Model: V85 TT

Subject: instrument cluster calibration update

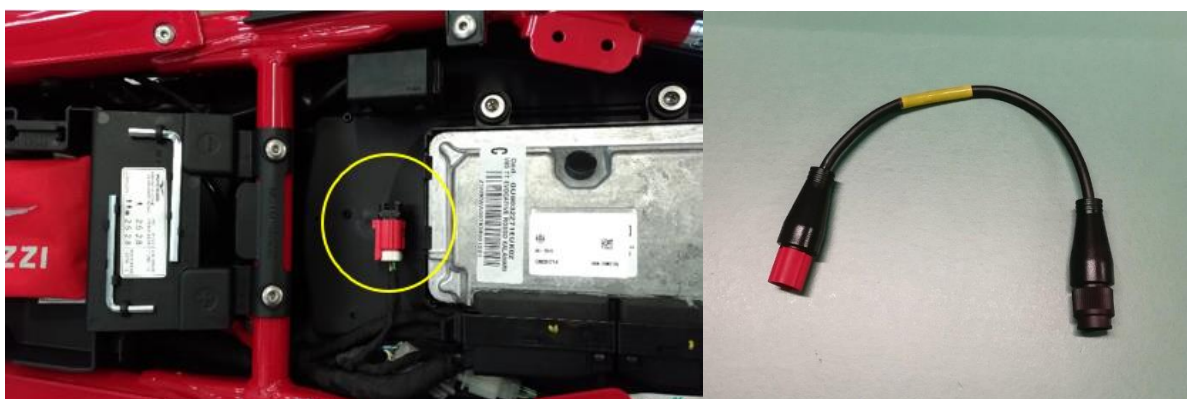
We hereby inform you that a new instrument cluster calibration dedicated to the model in question, is available by downloading it from the P.A.D.S. (update the instrument to the latest version available), which solves a problem concerning the non-update of the remaining fuel range value when on the NAVI page (see detail in red on the photo below).
